BULLETIN # 229

MILLER XMT350

HELP 8 MESSAGE WITH UNDERWATER WELDING

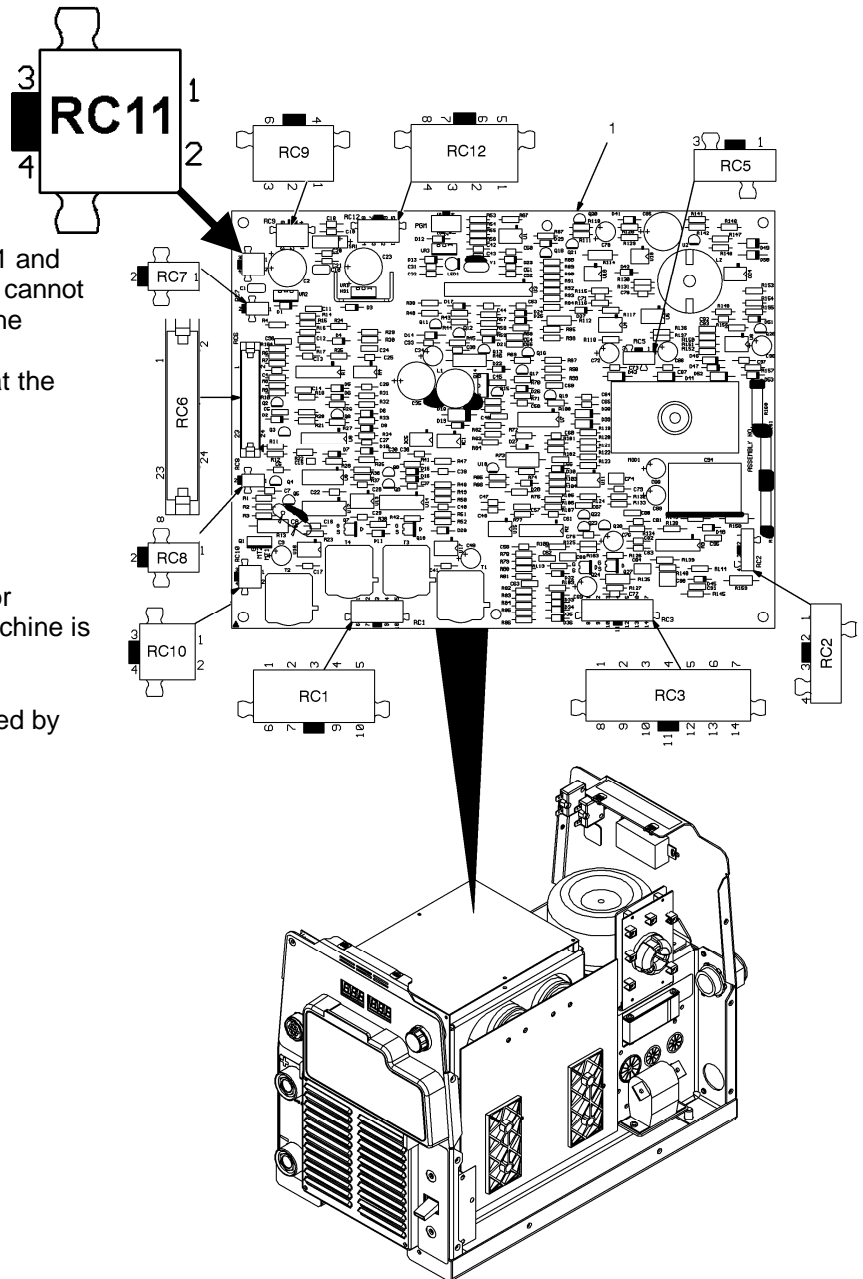
When an XMT350 is used for electrode welding under water, the error message HELP 8 may appear on the display. This is due to an unexpected value of voltage/current feedback when the arc is broken, due to the difference in conductivity of water in comparison to air. Disabling the boost circuit prevents this problem.

These instructions describe how to disable the boost circuit on an XMT350 to allow it to perform welding under water without erroneous display of error message HELP 8.

1. Isolate the power to the welder.
2. Remove the outer cover.
3. Locate 4 pin connector RC11 on the PC1 Circuit Board as per diagram.
4. Remove connector RC11 from PC1 and secure it with tape or cable tie so it cannot electrically contact other items or the cover.
5. Refit the outer cover and check that the welder operates correctly.

The boost circuit may be left disabled, or RC11 can be connected again if the machine is not being used for under water welding.
